Peach Bottom Atomic Power Station, Unit 2 and Unit 3
Renewed Facility Operating License Nos. DPR-44 and DPR-56
NRC Docket Nos. 50-277 and 50-278

Subject: MELLLA+ License Amendment Request – Supplement 6 Response to Request for Additional Information

Response to SRXB-RAI-18 in Support of PBAPS MELLLA+ LAR

SRXB-RAI-18

Figure 1 – Turbine Trip Feedwater Temperature Reduction

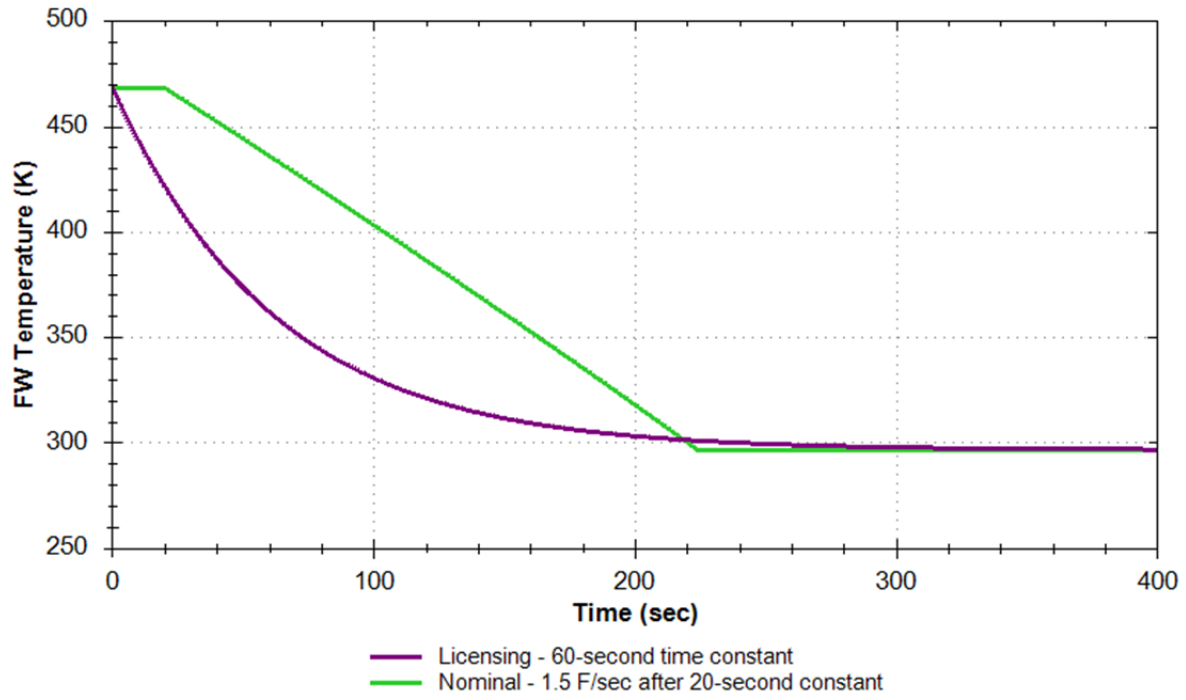
The NRC staff needs to better understand the performance of TRACG beyond Nucleate Boiling (i.e., in Transition Boiling and Film Boiling). The staff has questions regarding the use of a Minimum Film Boiling Temperature (Tmin) model in TRACG as a means of predicting the transition to film boiling and determining the Transition and Film Boiling Heat Transfer Coefficient.

- 1) Provide TRACG turbine trip with bypass (TTWBP) and dual recirculation pump trip (2RPT) sensitivity calculations for PBAPS in which the Homogeneous Nucleation Temperature is used for Tmin; include relevant plots of results.
- 2) Additionally, provide TRACG sensitivity calculations with more realistic assumptions in which both the Homogenous Nucleation Temperature and the Shumway correlation (as currently implemented in TRACG) is used. Include relevant sensitivity parameters (such as, but not necessarily limited to: operator response time, Tmin model, peak cladding temperature (PCT) and/or number of assemblies that exceed 2200 °F, peaking factor and feedwater assumptions); also include relevant plots of results.

For the TTWBP analysis, an expected feedwater temperature response is used in the sensitivity analysis. This nominal response is based on Peach Bottom Atomic Power Station (PBAPS) simulator data and decreases at a much slower rate. It also includes some added conservatism by assuming a constant feedwater temperature for 20 seconds, then a linear decrease of 1.5°F/sec to the condenser temperature. Both feedwater temperature profiles used in the analysis are shown in Figure 1.
